# UNITED STATES PATENT AND TRADEMARK OFFICE

# Office Action Summary

Application No.  
09/839,001

Applicant(s)  
Harald Apfelthaler

INVENTOR.  
JOHN A. DALLEN

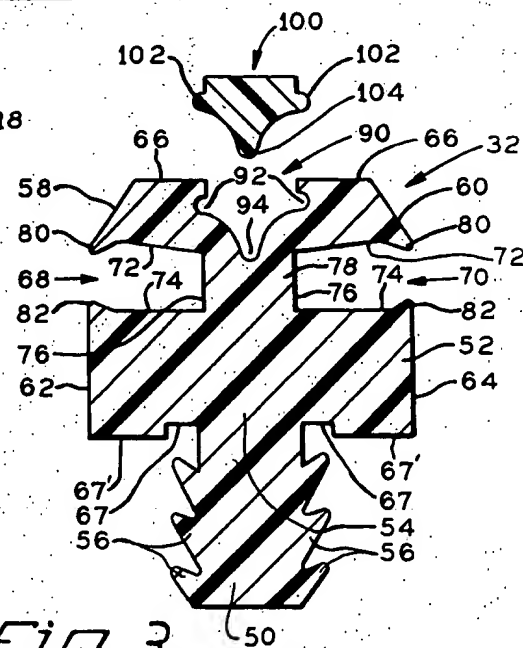
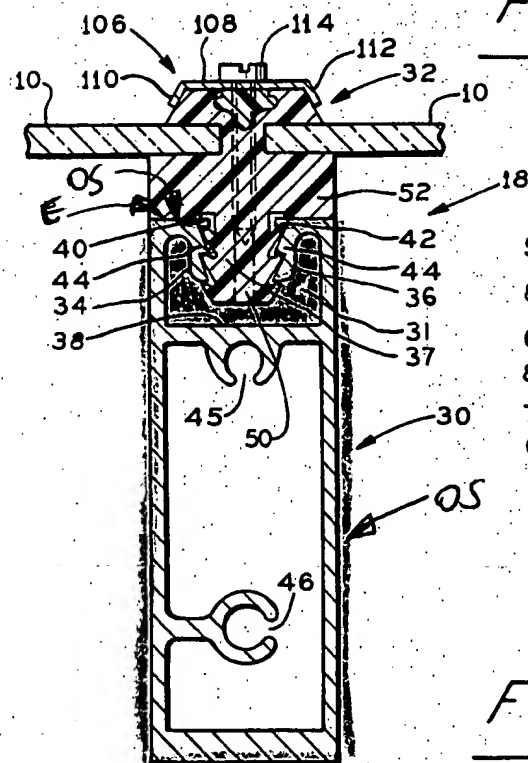
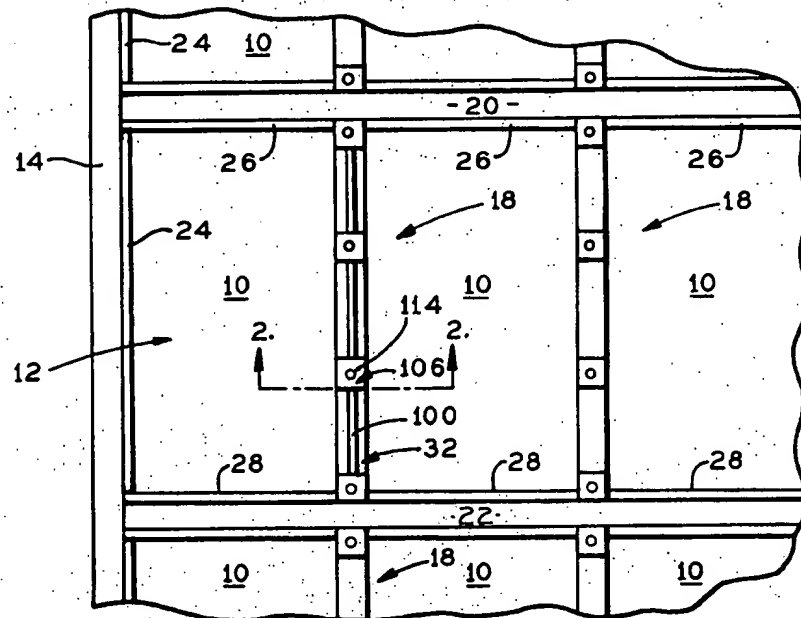
6. Claims 1-6,11,14,15 and 19 are rejected under 35 U.S.C. 102(b) as being anticipated by US Patent #3,766,698 to DALLEN. DALLEN discloses the use of a plug (32) in combination with a muntin (30) having an outer surface (OS, colored blue), an end (E), a hollow space (colored red), and inner walls (34,36), see the marked attachment; wherein, the plug (32)

includes a body (50) having a longitudinal slot (134), column 6, line 33-39 and column 7, line 20-30, that fits into the hollow space (colored red) of the muntin (30) and a flange (52) that is positioned on the outer surface (colored blue) of the muntin (30) and the plug body (50) press fits on the inner walls (34,36) of the muntin (30), column 6, line 33-39. In reference to claims 2-4, the slot (134) is coaxially aligned with the plug body (50); penetrates the plug body (50), see Figure 4; and receives a screw (114) that spreads apart the body (50), column 6, lines 33-39. Regarding claims 5,6,11 and 15, the slot (134) has a width/recess (90) at the upper end of the plug (32) different from the width (similar to 134) at the bottom end; wherein, the width/recess (90) is a groove that further includes a portion (92) also wider/greater than the width of the slot (134). In further regards to claims 14 and 19, the longitudinal slot (134) is coaxially aligned with the plug (32) and the body (50) includes a plurality of spring elements (56) extending therefrom that engage the inner walls (34,36) of the muntin (30).
